**Environmental
Protection Agency**

RE: STARK COUNTY
CITY OF ALLIANCE
DLW VENTURES LLC
CONSTRUCTION STORM WATER

NOTICE OF VIOLATION

Figure 1 – The sediment basin lacks an appropriate outlet structure.

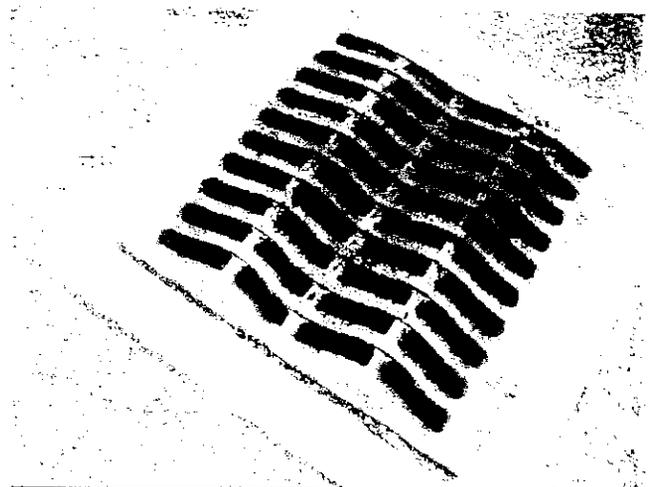
2. The sediment basin still lacks an appropriate outlet structure (Figure 1), and as a result, sediment-laden water is leaving the site without being treated. **This is a direct violation of the NPDES permit.** You must install a properly-designed riser pipe or skimmer device to treat the water before it discharges offsite.
3. No inlet protection has been installed on the storm drains (Figure 2). You must install an approved form of inlet protection on each grate in accordance with the *Rainwater and Land Development Manual* (Ohio Department of Natural Resources, 2006), available online at <http://www.dnr.state.oh.us/tabid/9186/default.aspx>.
